## Moorebank Precinct East Stage 2

### Noise and vibration independent review

Prepared for Department of Planning and Environment | 27 October 2017

Report J17102RP1 | Prepared for Department of Planning and Environment | 27 October 2017

**Figure 3.1 Noise measurement and assessment locations**

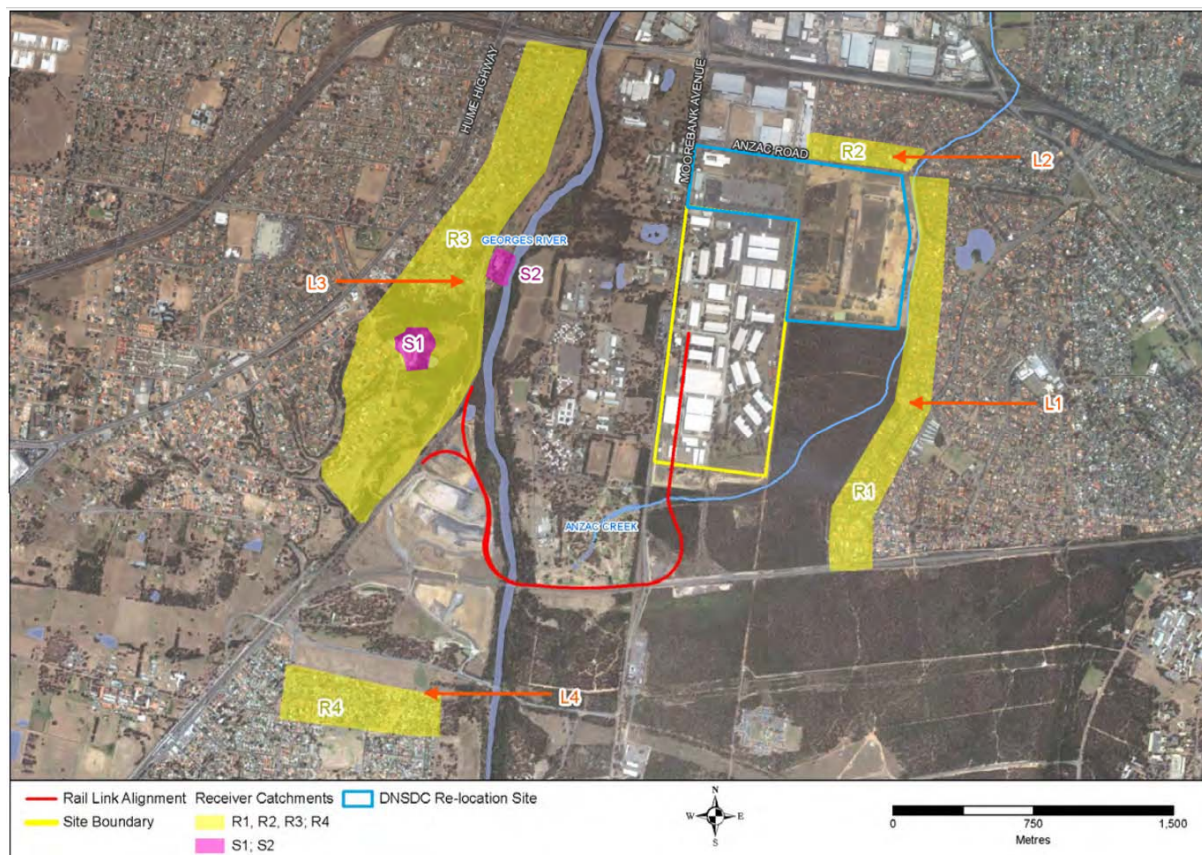
The use of only one monitoring location for each of the four relatively broad residential areas is identified as a limitation to the noise impact assessment. Normal practice is to include enough sampling spread across such large geographic areas to adequately represent the potentially most impacted locations.
